BEAVER VALLEY - UNIT 1

ATTACHMENT B

SAFETY EVALUATION

Proposed Change Request No. 95 amends the Beaver Valley Power Station, Unit No. 1 Technical Specifications, Appendix A concerning various administrative changes.

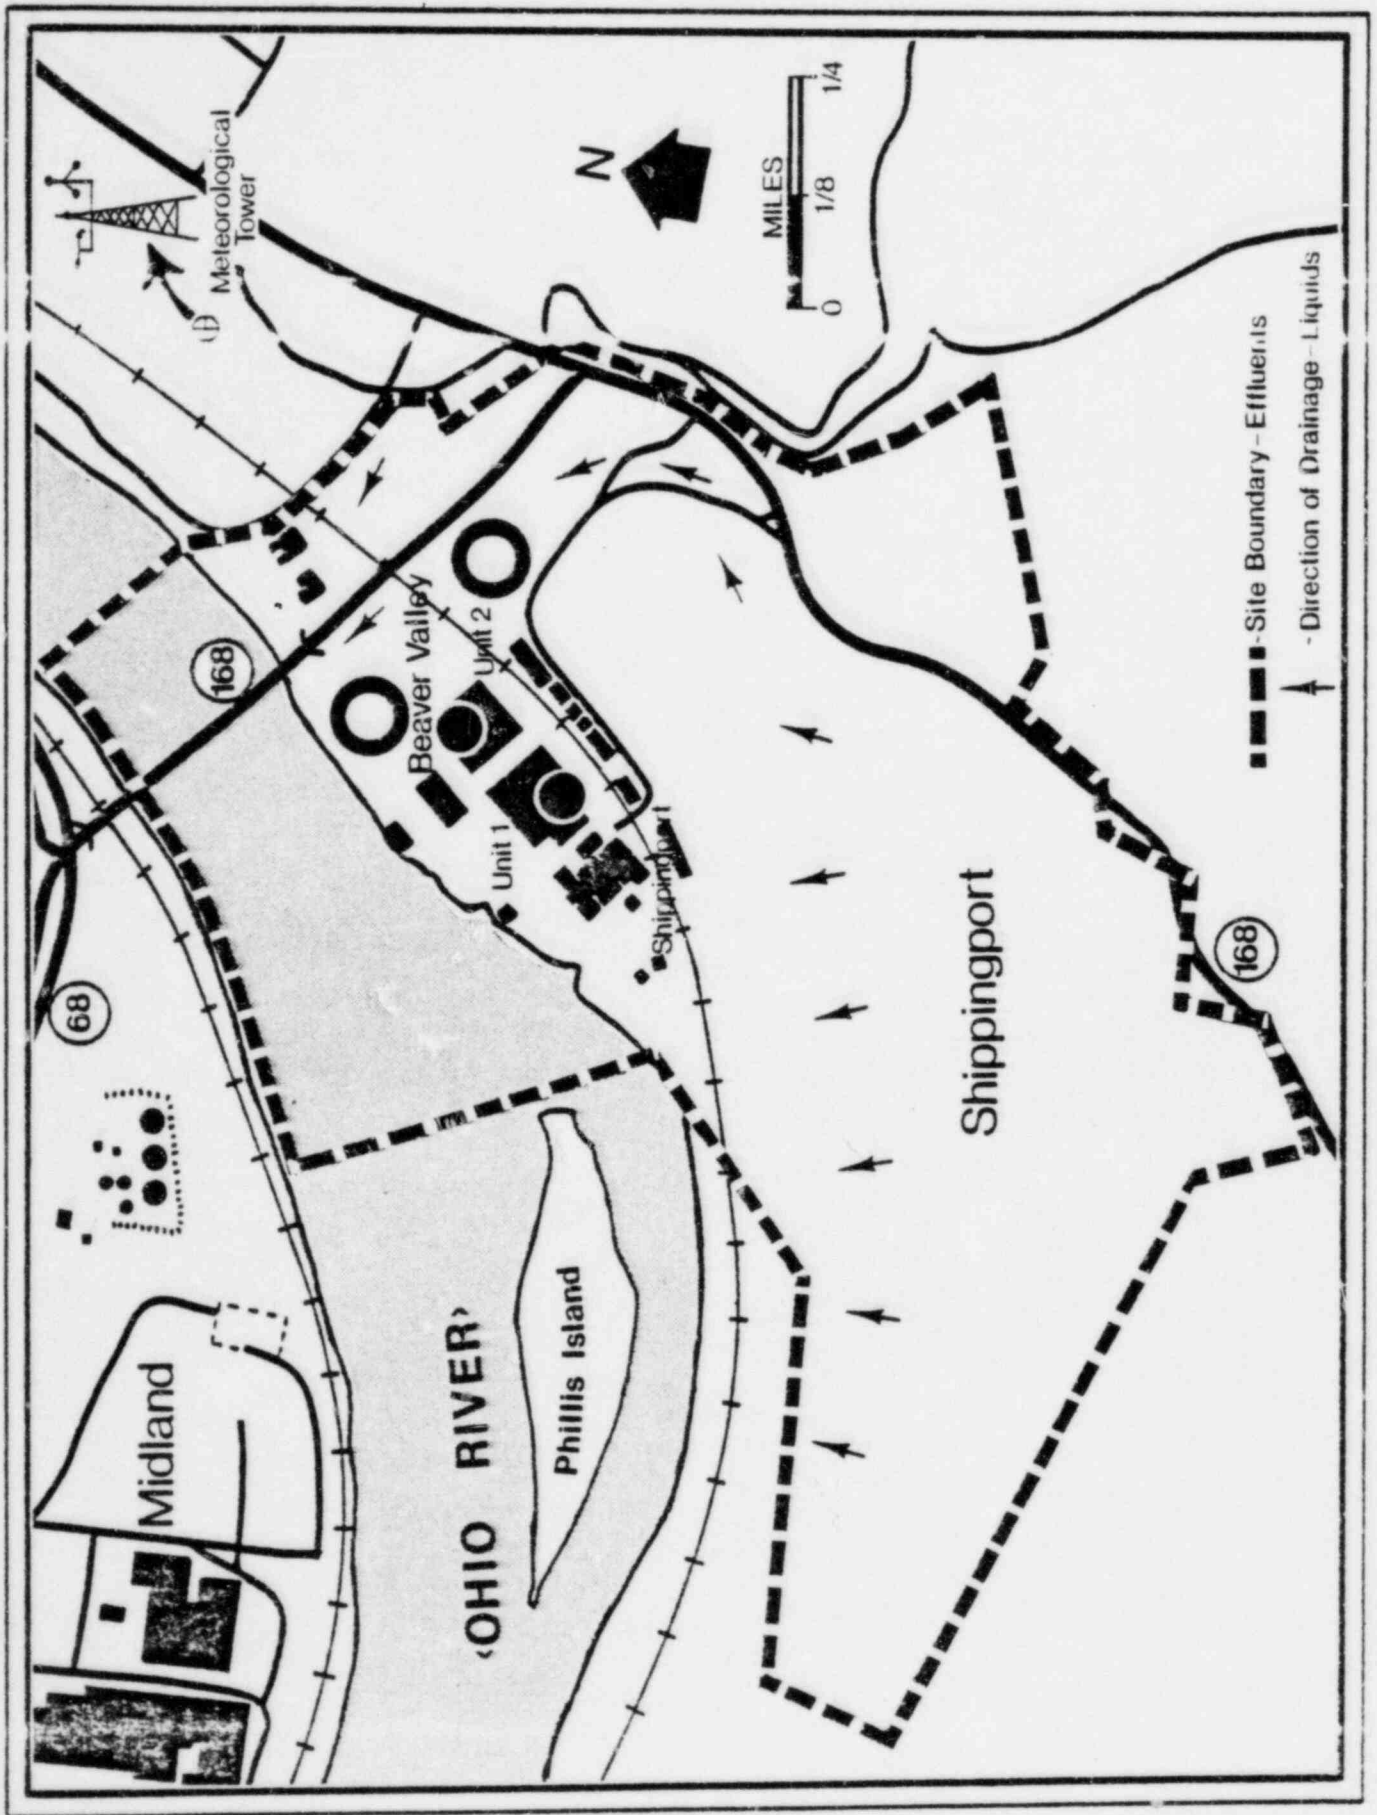
Section B 3/4.7.14 - Fire Suppression Systems, the applicable bases have been revised to reflect the above changes.

FIGURE 5.1-1

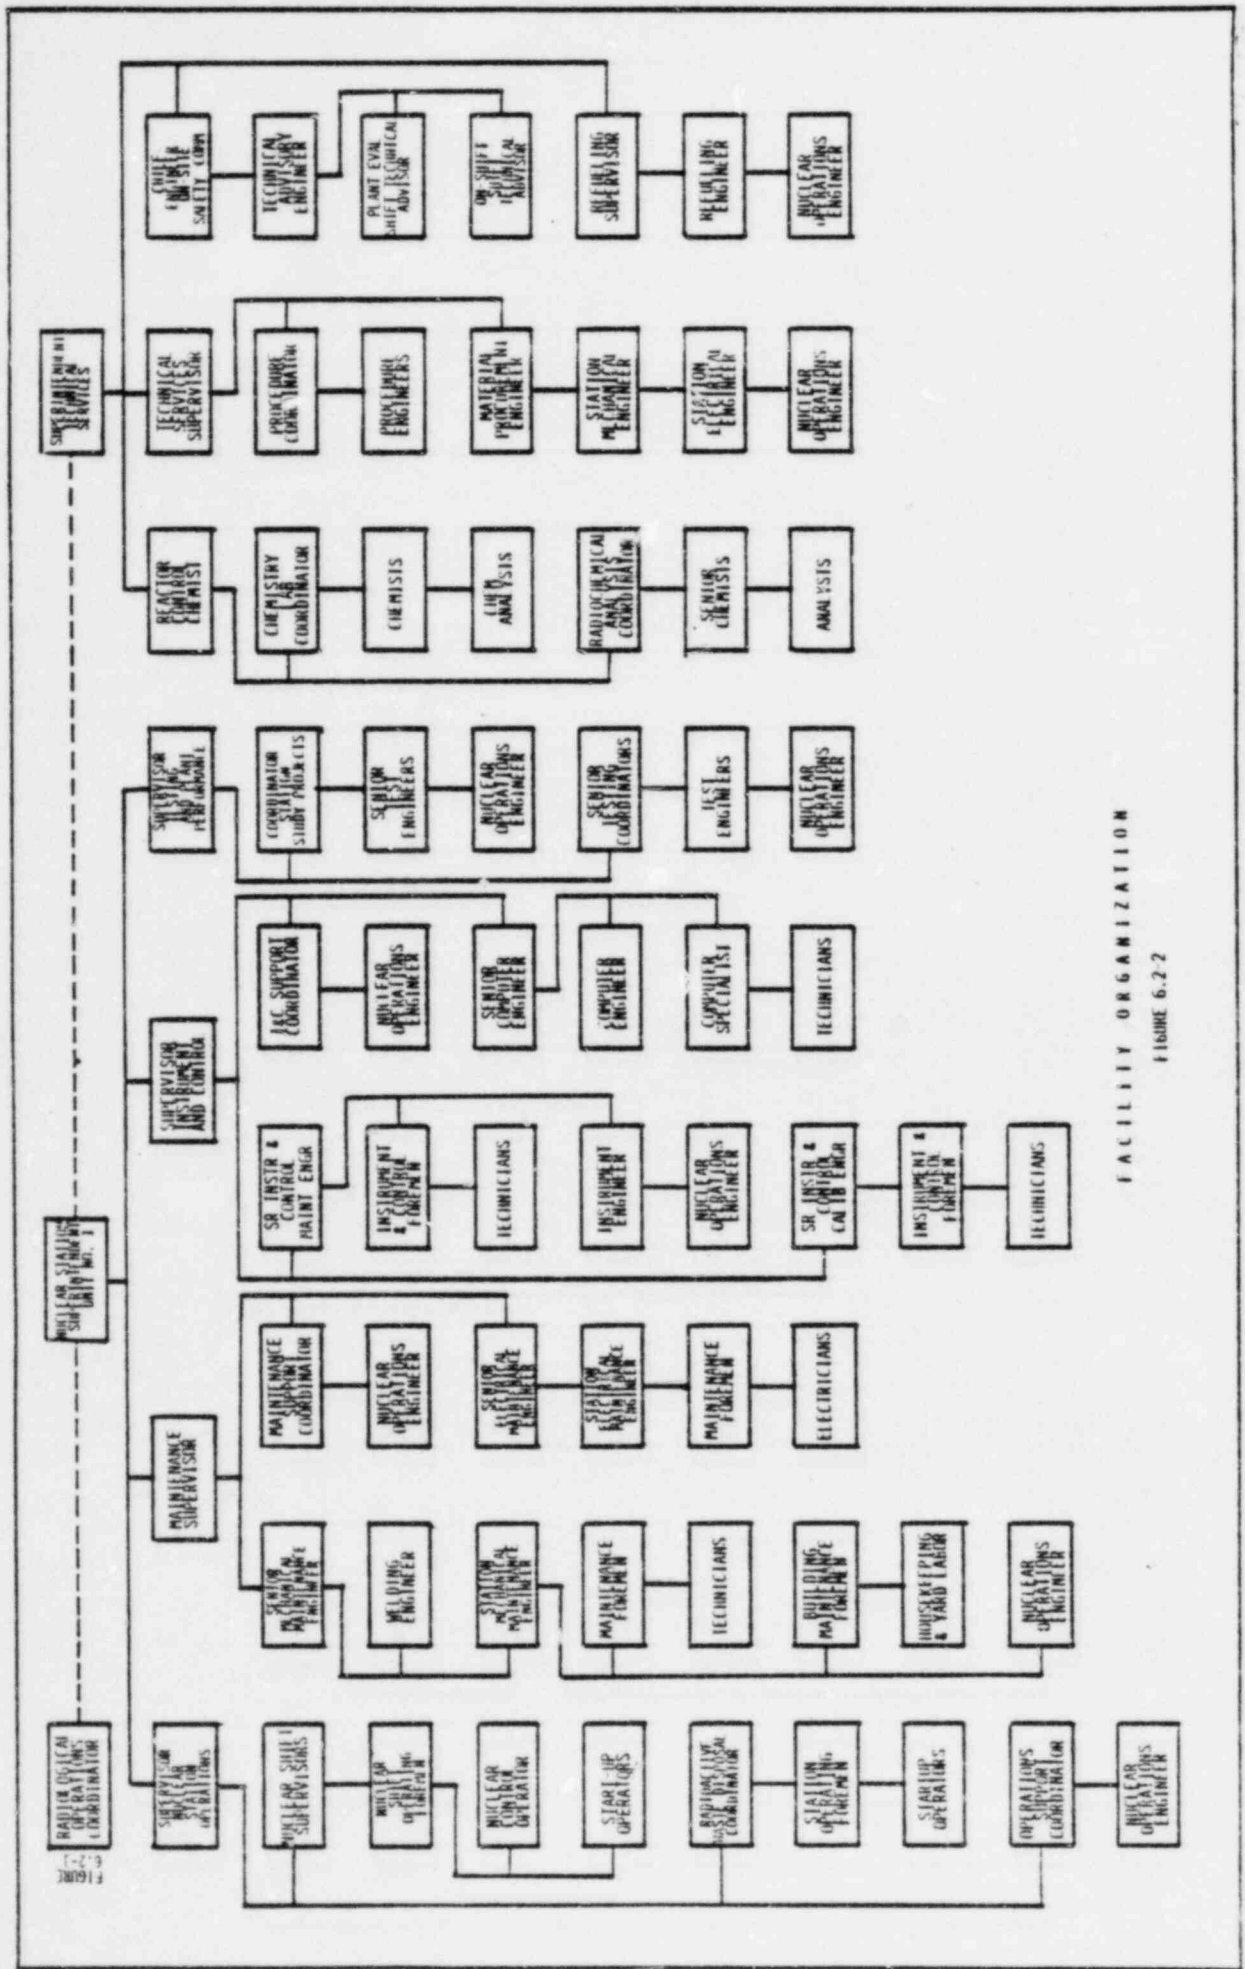
9. Figure 5.1-1 Site Boundary for Gaseous Effluents for the Beaver Valley Power Station: correct this figure by adding the "Meteorological Tower" as referenced in Section 5.8.1.
10. Figure 6.2-2, Facility Organization, has also been revised to reflect the reorganization of Station Engineering. The functions deleted from Station Engineering responsibility have been incorporated into the Nuclear Engineering Department.
11. Section 6.5.1.2 revises the title of one of the OSC members from "Senior Engineer - Station Engineering" to "Project Engineer - Nuclear Engineering Department" and adds an additional member "I&C Supervisor".

9. Figure 5.1-1 Site Boundary For Gaseous Effluents for the Beaver Valley Power Station, has been revised to identify the location of the Meteorological Tower as referenced by Section 5.8.1. This figure had been revised by the RETS (Amendment 66) and the location of the Meteorological Tower had been omitted. This change is not a safety concern and does not affect the UFSAR.
